The Grove staff review

Proposed Grove Development

Technical Analysis Report On Traffic Review Process

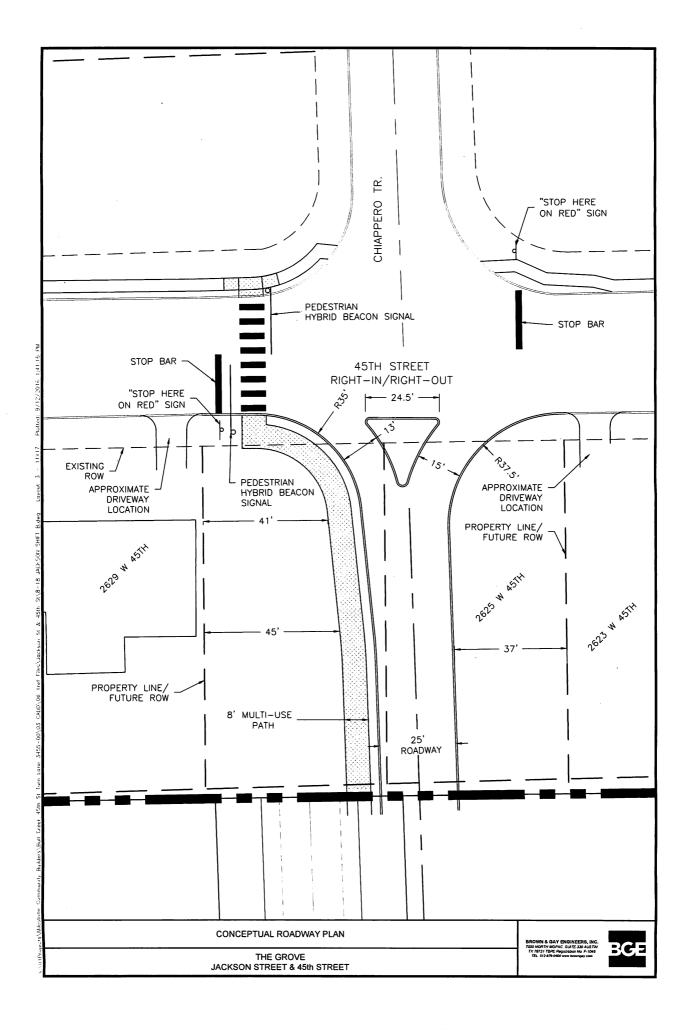
Notwithstanding the foregoing, and for clarification, the most recently proposed intersection of Jackson Avenue and 45th Street that is being considered by staff simultaneously with the Addendum remains the Applicant's proposed configuration of that intersection. That proposed intersection will be (i) right-in, right-out only, and (ii) aligned with Chiappero Street, as depicted in the attached conceptual design. The City's TIA Memo calls for this connection, and the enclosed conceptual design was provided to staff to answer any questions over how this connection might occur. Withdrawal of the Addendum does not mean that this connection or the proposed configuration is also being withdrawn. The Applicant understands that the enclosed conceptual design of this intersection has, subject to review and approval of final construction drawings, been accepted by the City staff as a generally and conceptually feasible approach to this intersection.
